**PLANNING COMMISSION
MEETING AGENDA
SPECIAL/STUDY MEETING**

July 26, 2011

9. PRELIMINARY SITE PLAN APPROVAL (SP 970) – Proposed Granite City Food & Brewery Restaurant, South side of Big Beaver Road, East of Troy Center Drive, Section 28, Currently Zoned BB (Big Beaver Form Based Code) District

Preliminary Site Plan Review For City of Troy, Michigan

ST. MARK COPTIC ORTHODOX CHURCH OVERALL PROPOSED SITE PLAN

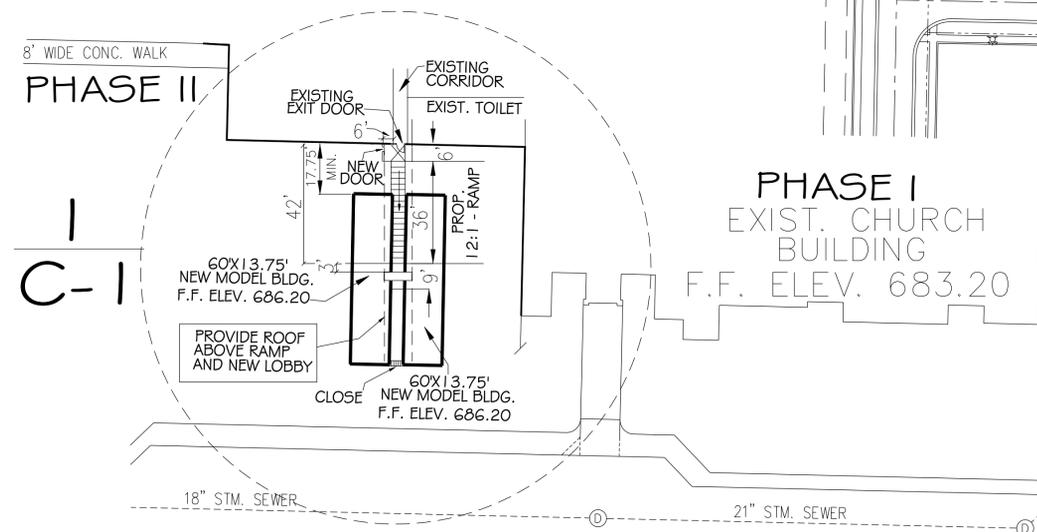
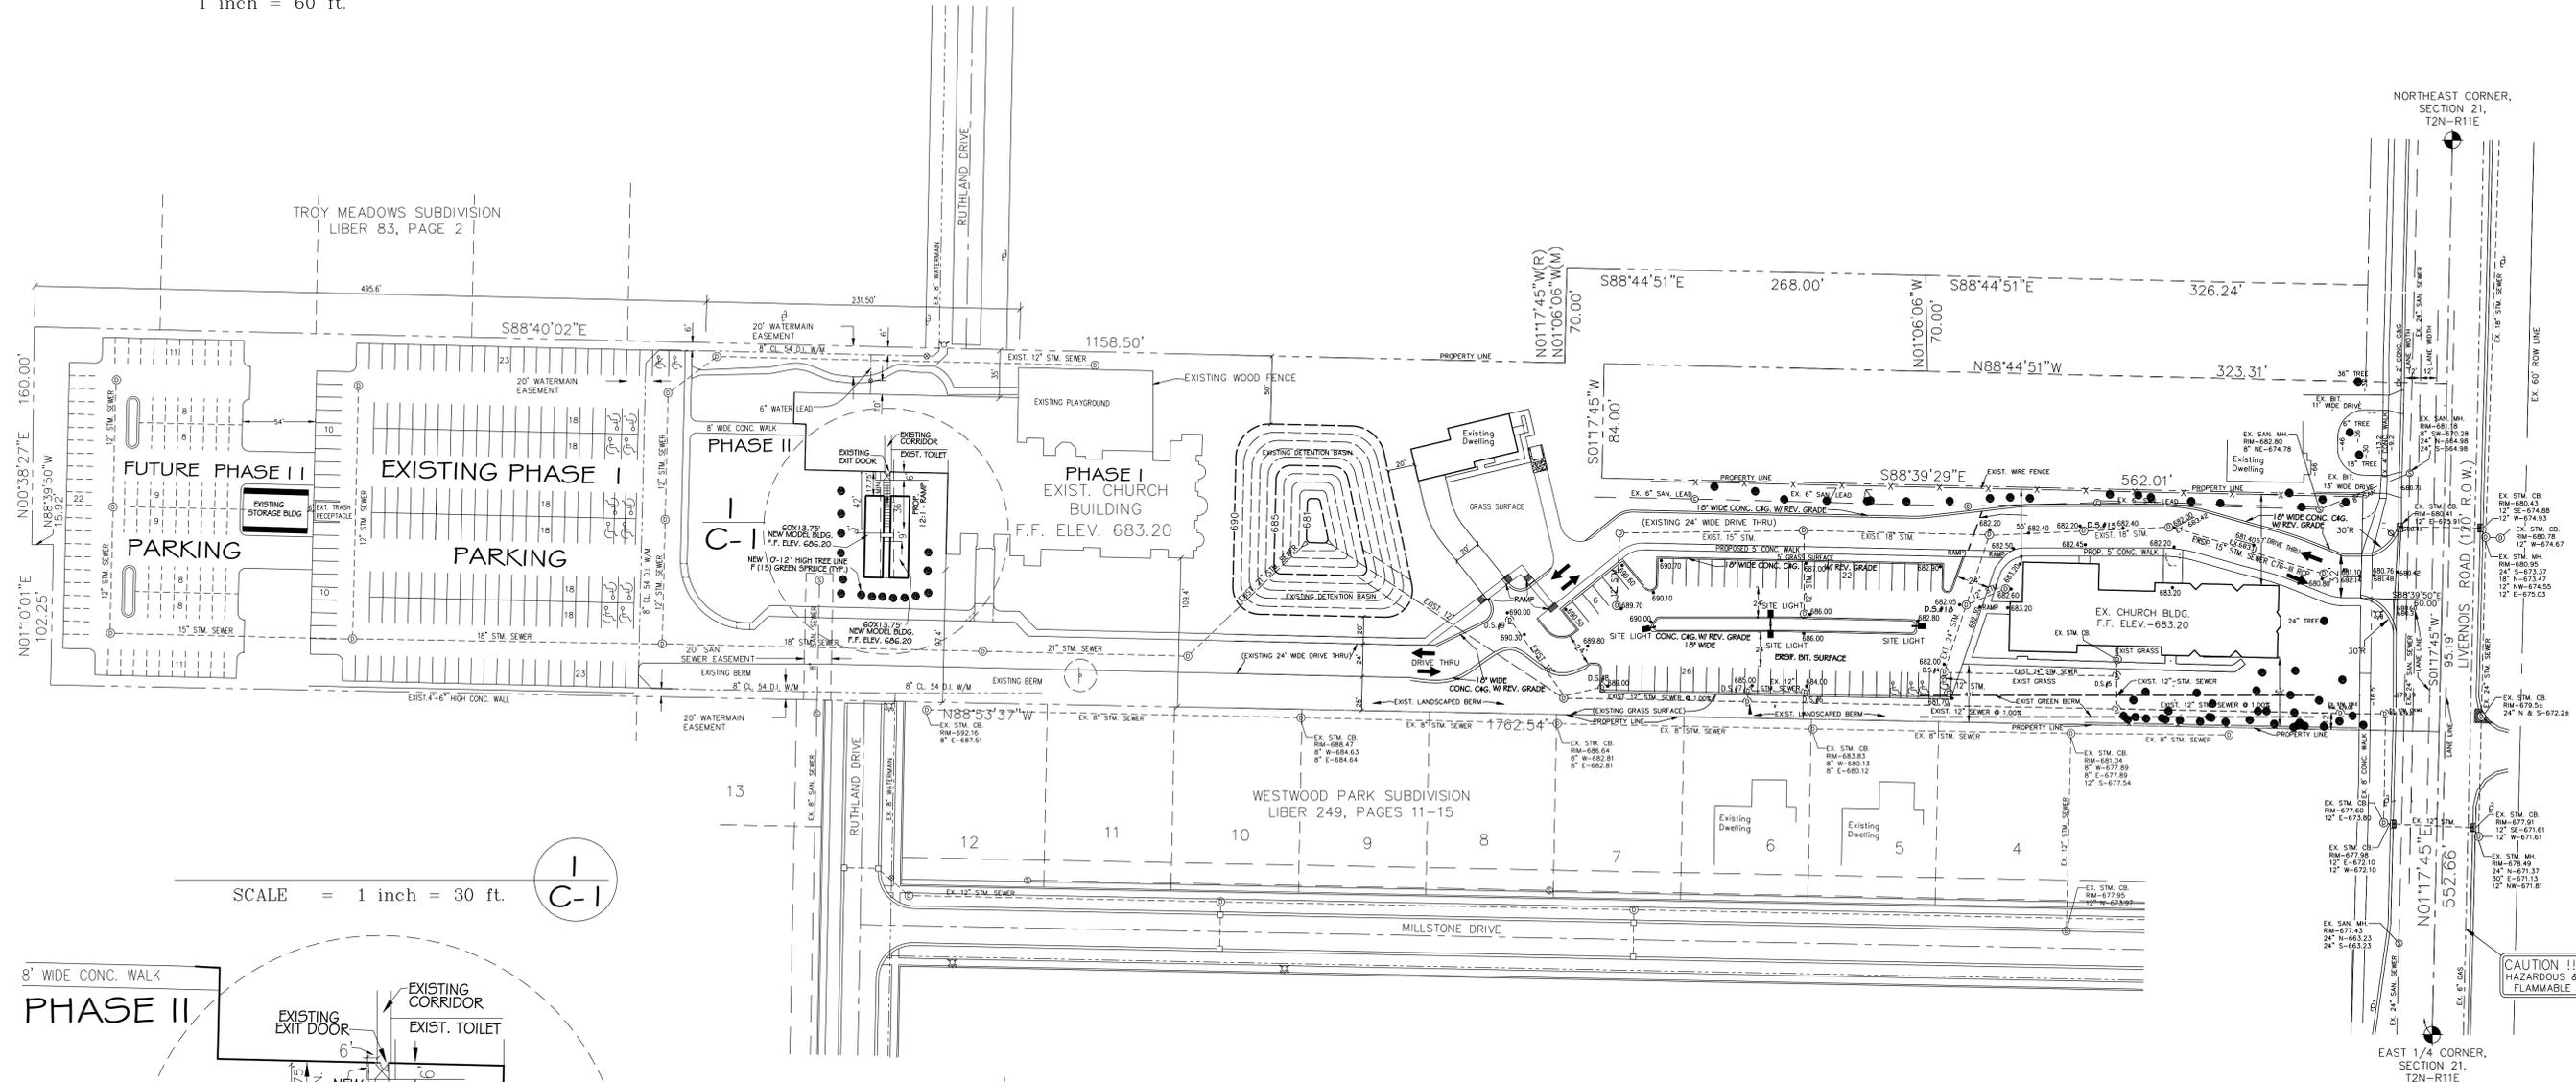
The proposed location of the trailers is in an area where a building has been conceived since the original approval of the main new Church structure. The area is open space with turfgrass. The project would add approximately 2,000 square feet of impervious area. It is not clear what the existing site's lot coverage or open space calculations total, so we cannot make a formal determination in this regard. However, the site is significant in area and we also understand the adjacent residential property to the north has been purchased and is now part of the overall property. The trailers appear to be situated along an existing sidewalk extending south from the building which we observed during our site visit and on aerial photographs, but which is not reflected on the site plans. We have no objection to the location of the trailers, and no additional alterations to other site design elements are proposed.

We can confirm that the location of the trailers would meet minimum requirements for setbacks at this location, but we cannot provide detailed analysis of the proposed setbacks in the absence of more formal drawings. Also, we cannot confirm that the project meets height requirements, lot coverage requirements, or any other element of the area, bulk, and height standards of the Ordinance.

We do not necessarily object to the placement of the two semi-permanent buildings for the purpose of bridging the gap between the current available facilities and the final phase. The buildings would be permanently mounted on a foundation and would be required to secure building department approval. Their nature as pre-manufactured units does not necessarily impact their appropriateness from a zoning perspective. However, these buildings were not conceived at the time of the original approval and therefore represent a new proposal that required a revised special use permit for the Church.

Given this fact, a complete application meeting the minimum requirements of Section 8.05 (with any submittal requirement adjustments made by the Zoning Administrator). At a minimum, this revised submittal must show the specific limits of construction, the elevations and floor plans of the proposed structures, proposed materials, have full site details as required in Section 8.05, and provide detailed, updated information on as-built conditions and proposed landscape improvements to be made as part of this specific project. As it stands, the submitted sheets are taken from several former proposals with dates as far back as 1999. Current, newly dated drawings with the information listed above must be provided to give the Planning Commission a clear and accurate description of the existing conditions and the specific elements of the proposed project.

Therefore, we recommend the Planning Commission postpone action on the applicant's request until such time as a complete application is provided to the City.

Landscape Plan

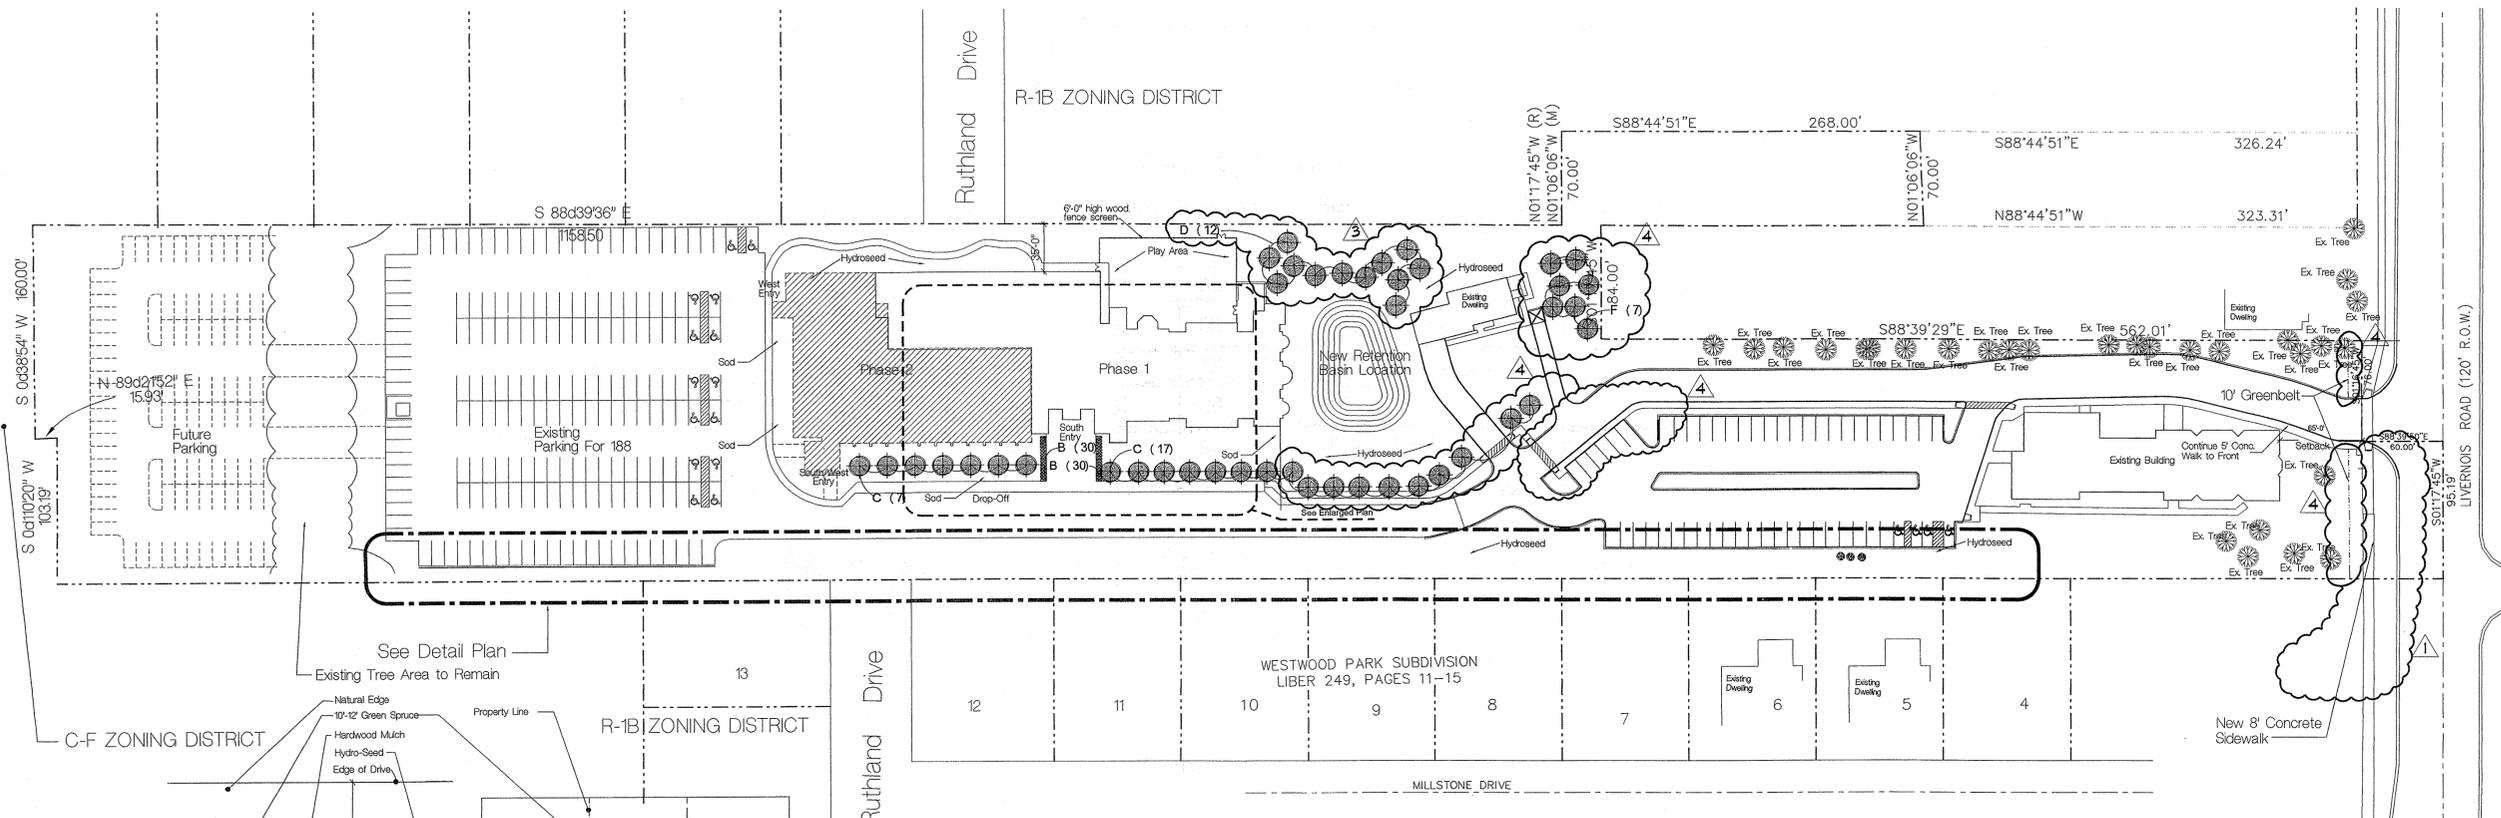
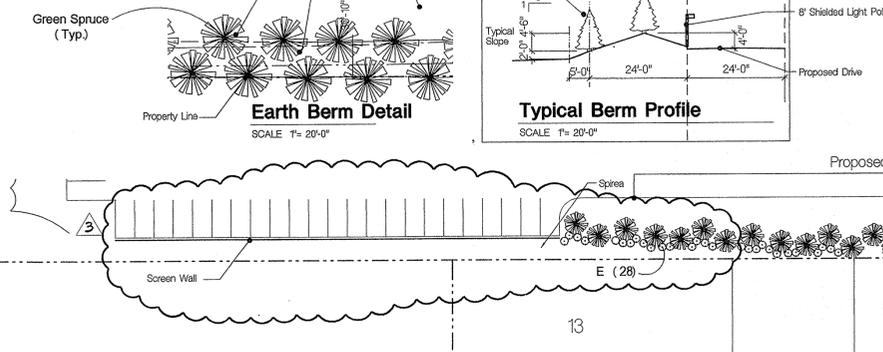
The submitted materials include a variety of different potential approaches to landscaping that have been proposed at various points from 1999 until present day. None of these drawings appear to reflect the as-built conditions on the site, although one set of plans was provided that does include a current revision date, although the content of the plan is largely left unrevised. It is our understanding from conversations with the applicant, and from this newly dated drawing, that they intend to install landscape screening to obscure the potential view of the trailers from the south. It is unclear if the other drawings provided reflect any proposed changes or if they are simply being used to show the trailer location. For instance, a drawing from April of 1999 shows a row of screening trees along the north side of the existing driveway, but these trees are again shown as "proposed" on a plan from 2000, and they were never planted and do not exist today. It is unclear if the applicant intends to plant those trees at this time. A current, new landscape plan

based on as-built conditions will be required to show specifically what is proposed for this project.

ORIGINAL ISSUE DATE: APRIL 18, 2008
PEA JOB NO. 2008-059
SCALE: 1" = 30'
DRAWING NUMBER: L-1

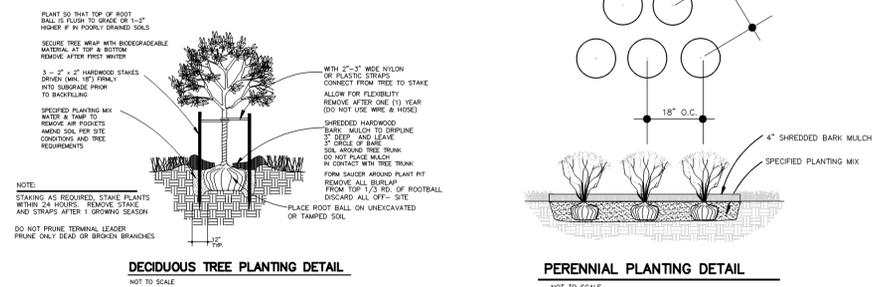
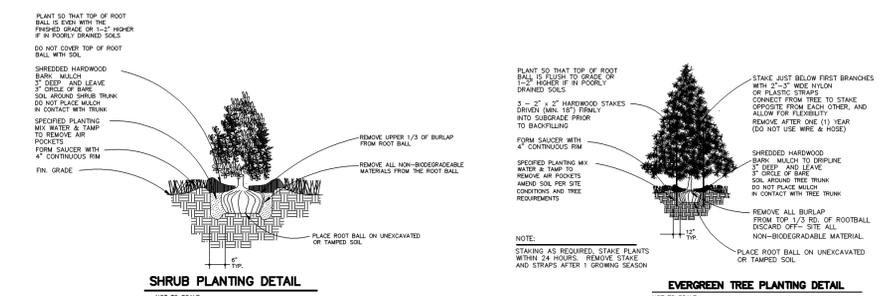
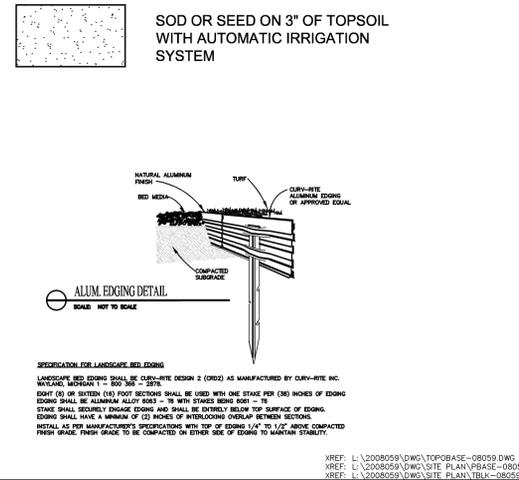
The application includes a detailed landscape plan. The plan shows the requirements and proposed conditions for the greenbelt, street trees, and landscaped area. It does not detail how the project complies with the parking lot landscaping requirements.

The site plan shows existing 4 street trees on site, and details plans to add 5 new trees. The landscape plan does not clearly show the existing trees proposed to remain or label them, but they can be faintly seen through the textured pattern identifying the landscape area. The Ordinance requires that the greenbelt shall be landscaped with a minimum of one (1) deciduous tree for every thirty (30) lineal feet, *or fraction thereof*, of frontage abutting a public road right-of-way. This site has 280 feet of frontage, requiring 9.33 (10) trees. An addition street tree must be added to meet minimum Ordinance requirements.

Items to be Addressed: Add one street tree.

5. Add one street tree.
6. Show the location of existing cross access easements on abutting properties and the location of proposed cross access or joint drive easements on the subject property.

PROJECT NUMBER
110215
 SHEET NUMBER
A110

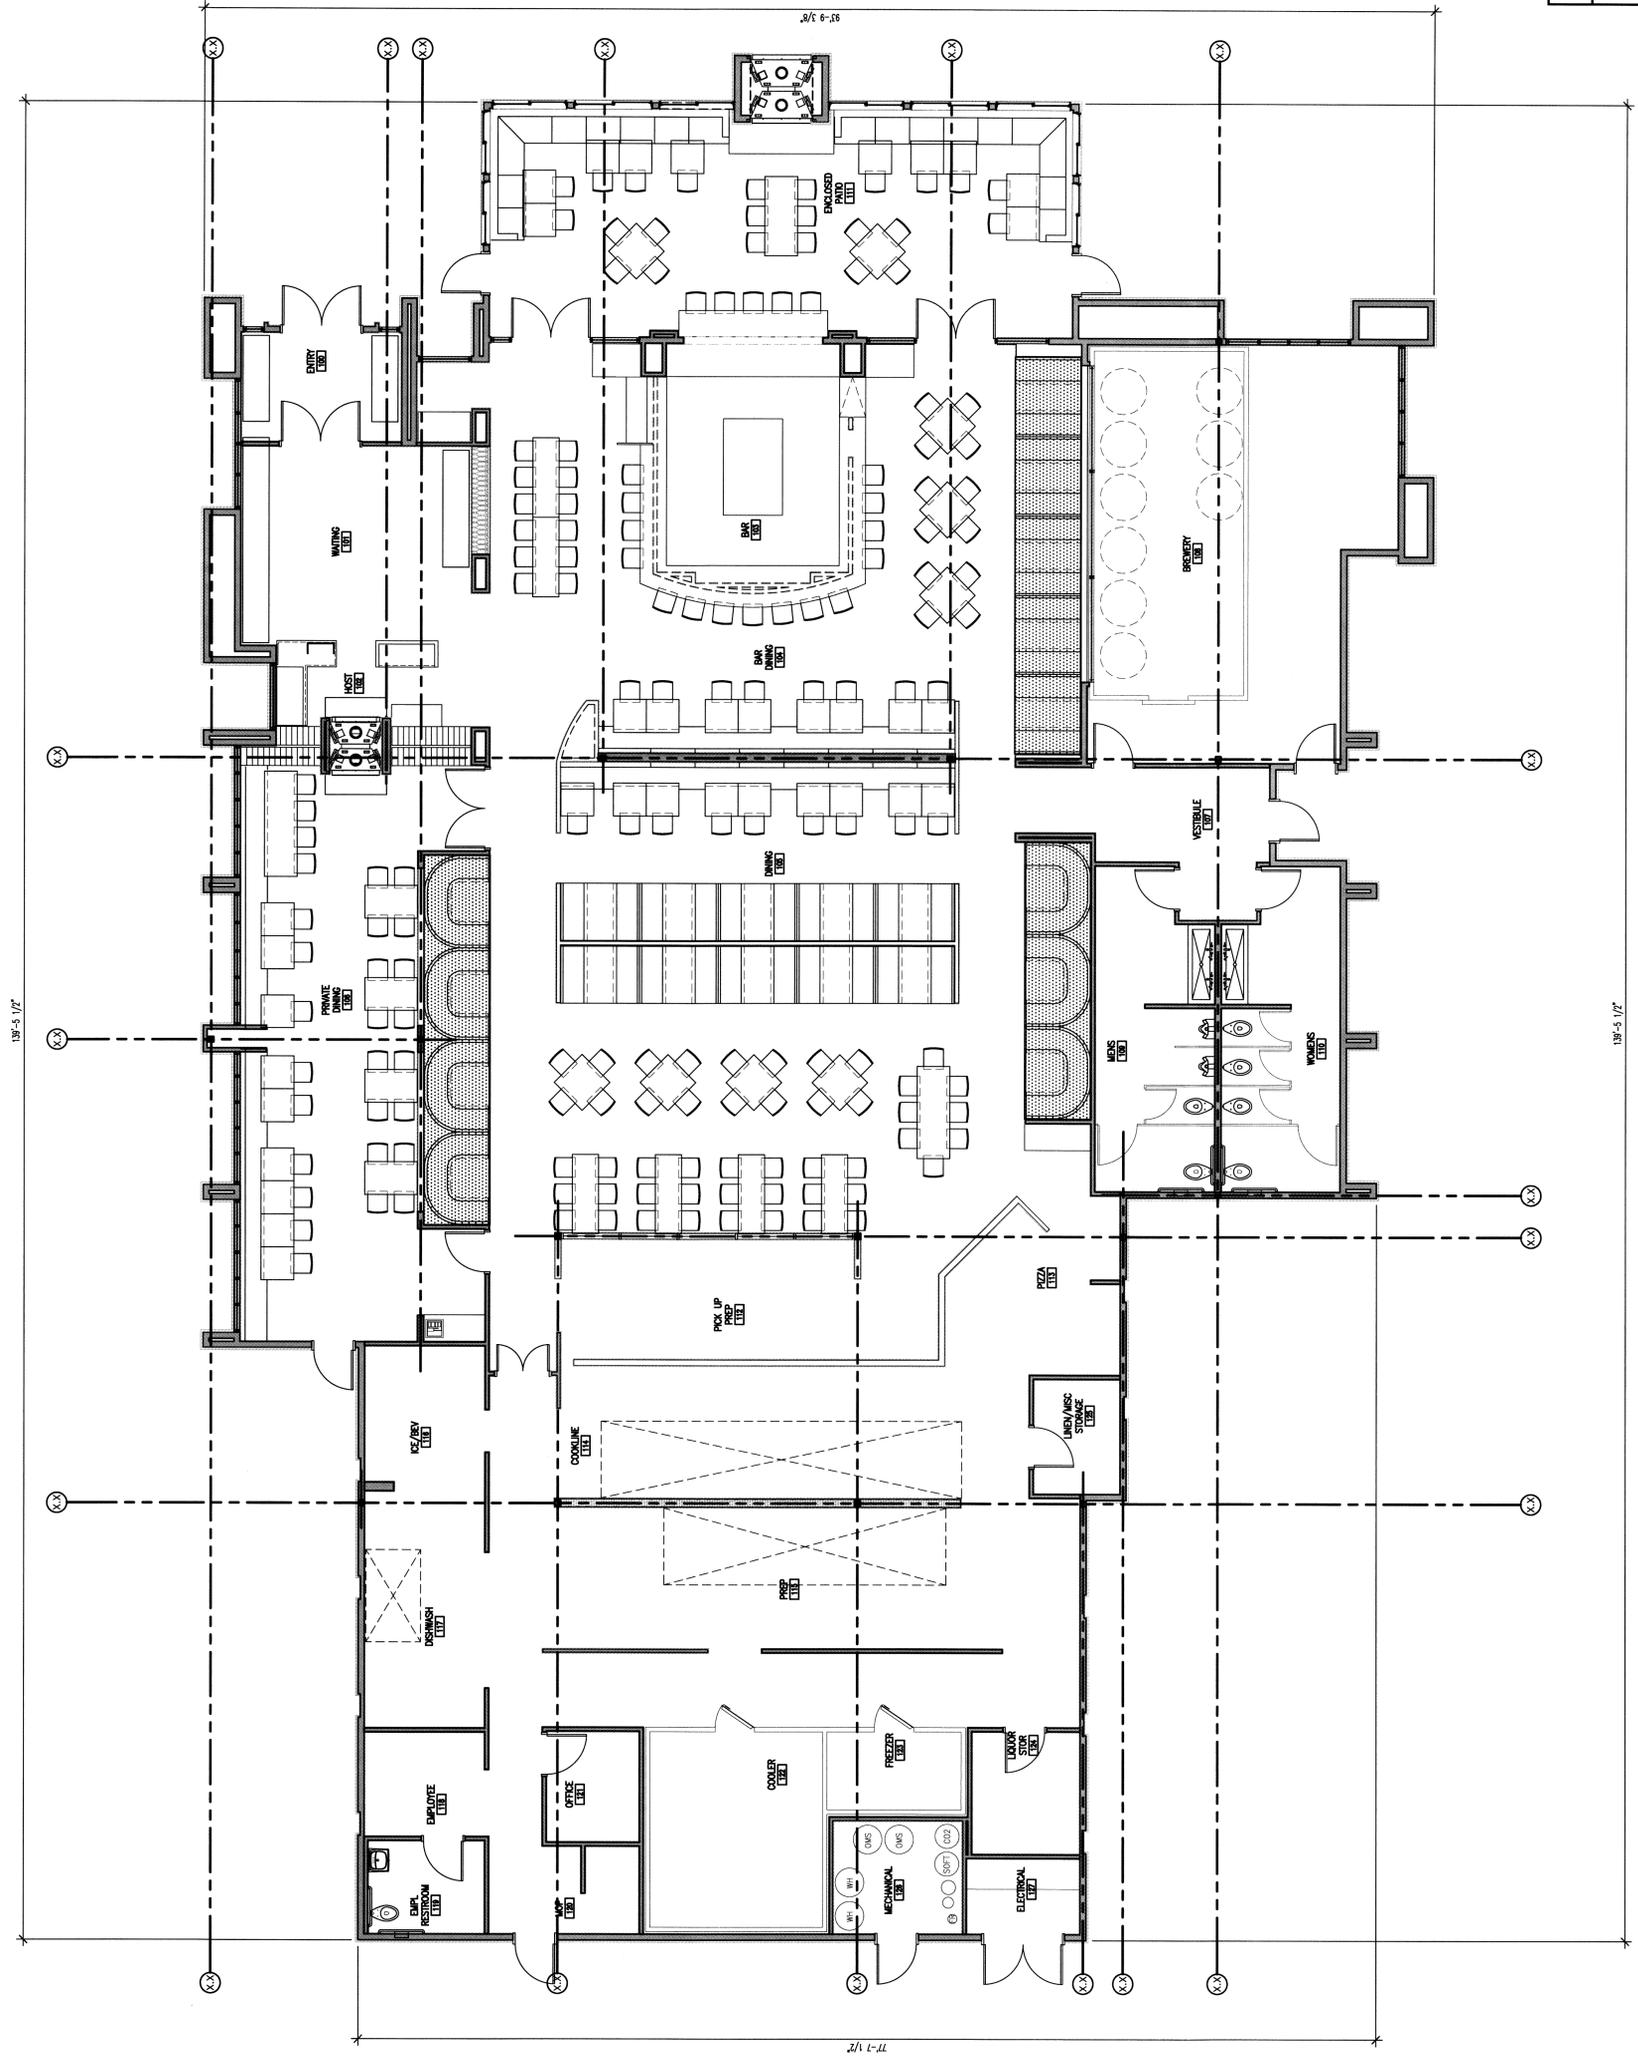
2. Preliminary, dimensioned floor plans must be provided. The floor plans have very limited dimensions (overall building length and width) but no other interior dimensions. Full dimensions should be provided.

7. Provide full dimensions on the preliminary floor plans.
8. Provide a lighting plan indicating proposed photometrics, height of light fixtures, proposed light fixtures, and proposed methods of shielding.
